From: The Columbia County Building Department
Plans Review
135 NE Hernando Av.
P. O Box 1529
Lake City Florida, 32056-1529

James Beach Owner/Builder lot 33 of Hills at Rose Creek

On the date of March 9, 2006 application 0603-03 and plans for construction of a single family dwelling were reviewed and the following information or alteration to the plans will be required to continue processing this application. If you should have any question please contact the above address, or contact phone number (386) 758-1163 or fax any information to (386) 754-7088.

1 OPENING ELEVATION
1/4" = 1'-0"

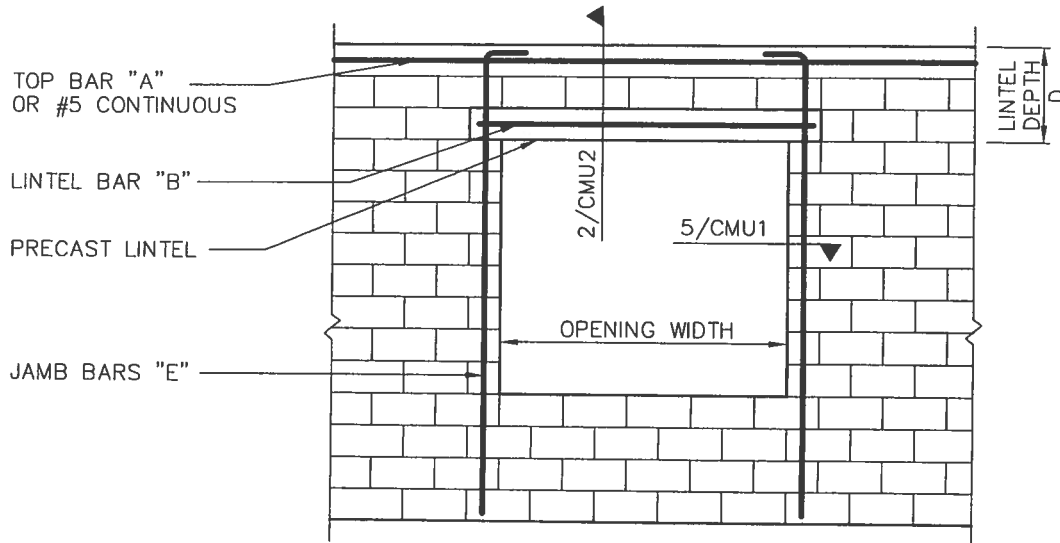
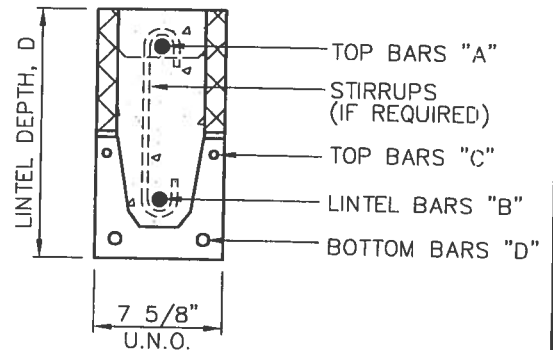
- ✓ 3. Please provide the header beam or the masonry lintel that will be used to span the 18' garage opening and show the attachment method to the foundation of the supports members.

| MASONRY OPENING | LINTEL MARK | LINTEL DEPTH D (IN) | MASONRY REINFORCING | | | PRECAST LINTEL REINFORCING | | JAMB BARS "E" |
|---------------------------|----------------|------------------------------|---------------------|--------------------|----------|-------------------------------|--------------------|---------------------|
| 18'-0" GARAGE DOOR LINTEL | E | 16 | (1) #5 | (1) #5 | #3@8 | (2) #4 | (2) #6 | (2) #5 |
